MEMORANDUM

Subject: Vishal Narula
d(4) Floor Area Ratio Variance
Block 27.06 Lot 128
14 Dickens Drive

Date: October 25, 2021

Table 2: FAR Analysis

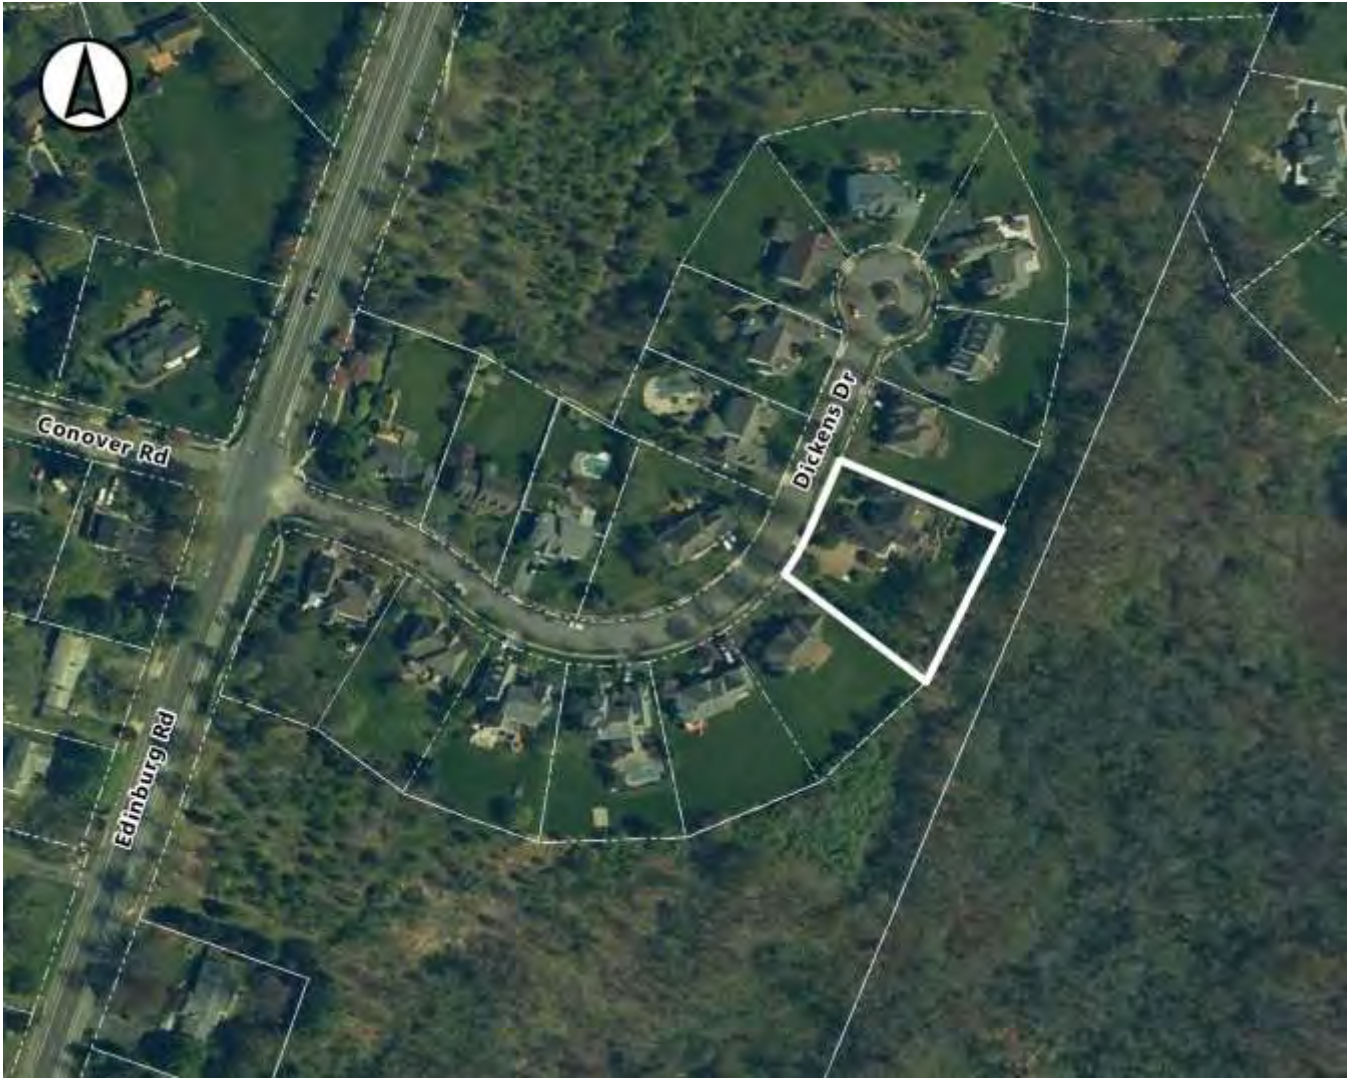
The applicant and the Board should discuss how the proposed FAR compares to the existing FARs in the surrounding area. To help visualize this comparison, we have provided the following table and map which identify those dwellings along Dickens Drive which exceed the FAR standard established by the R-20 District. This information was taken from the Township's tax information. In those instances where the FAR was unknown, our office provided an estimate based on Geographic Information Systems (GIS) data. Please note that pursuant to Section 200-174E., the FAR was based on a lot size of 32,670 square feet for all of the properties analyzed.

As shown, two (2) of the seventeen (17) dwellings in the surrounding area exceed the FAR standard established by the R-20 District.
